STRAIGHT EDGE RULE SE-48

AS BUILT

NEWPORT BLVD.
BRIDGE TO GRAPMAN AVE.
HIGHCLIFF DR. OVERCROSSING
BRIDGE BOX-2
BARRIER RAILING
DETAILS, TYPE I

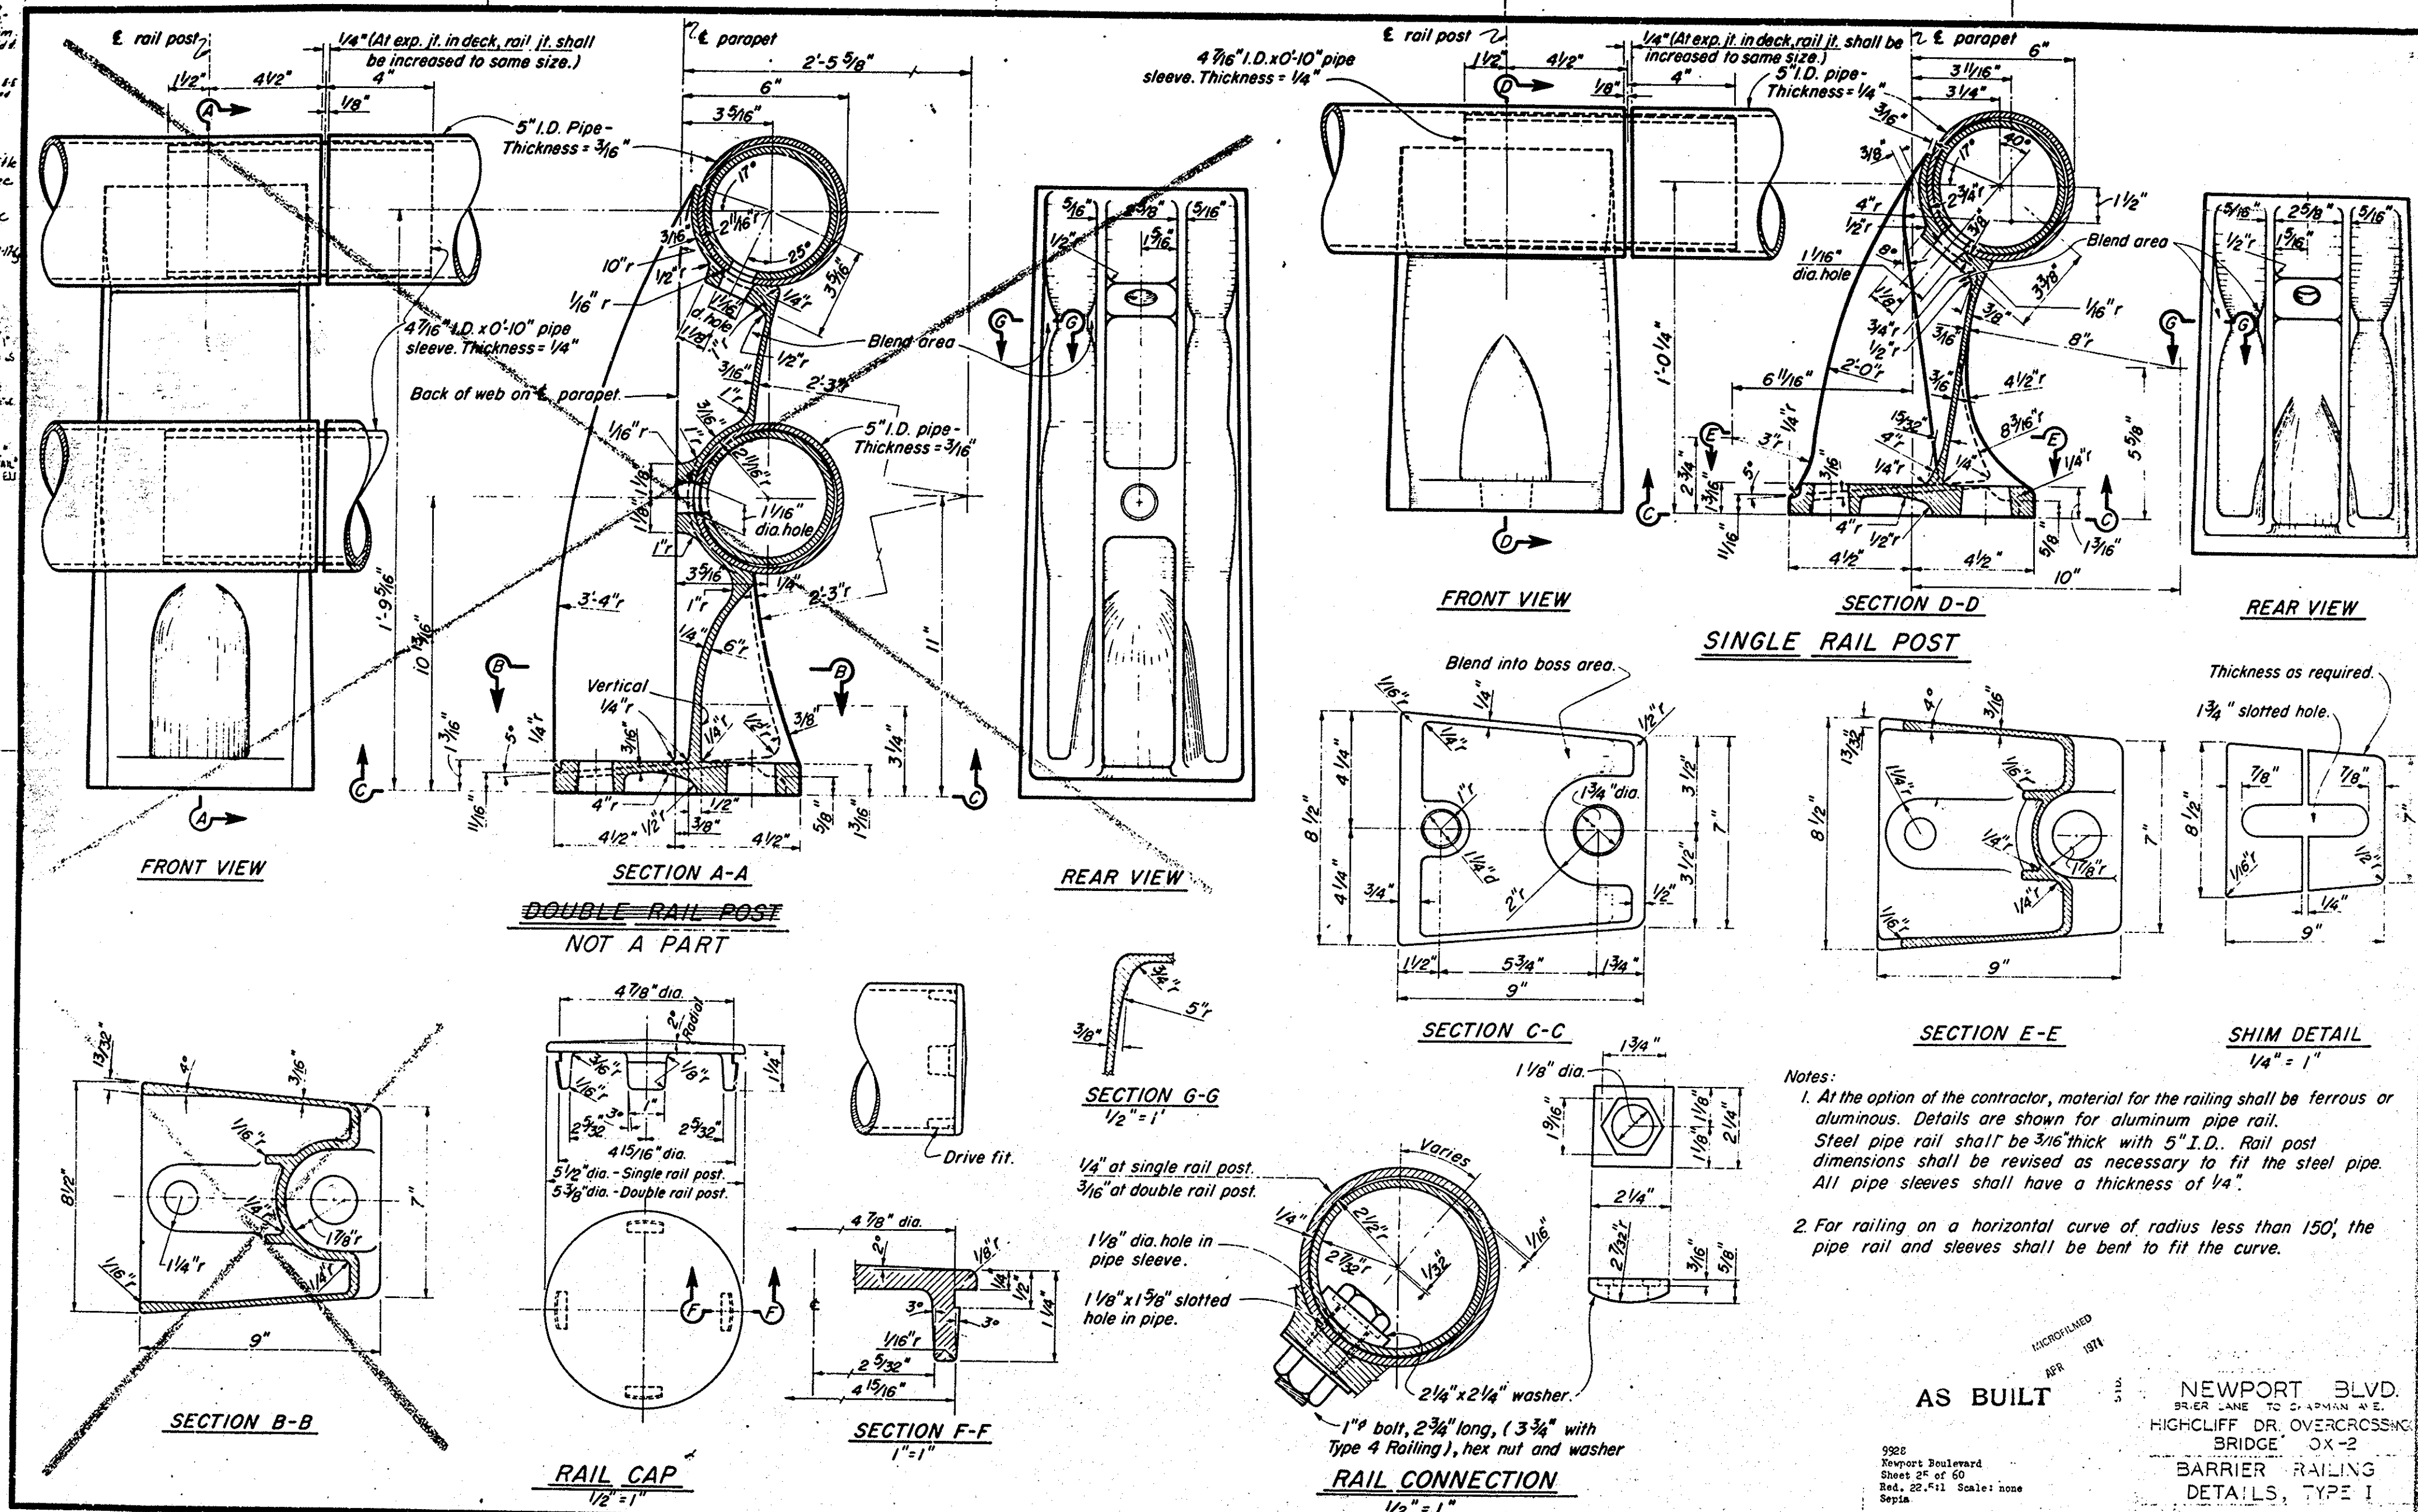
Rev. Added 40' on
section A-A & D-D.
Added a "long dim
" nail in section d.
1-60 RTK

changed Dim. in Sec 8-5
to 1 1/2". Revised
on true Sec. 8-6
1-72 J. S. S. 11

changed Dim. in Sec. 8-6
3/8 to 1 7/8. Revised
on form Sec. 0-6
189 12-8-11

Rev. Notes, lower
Right Cor. Rev. Title
Block + Co. Rt. Sec.
Block, Deleted
Signature Block
+ Block above
Co. Rt. Sec. J1112-124

Revised title page
12-87-88
26 Feb 65 EJS
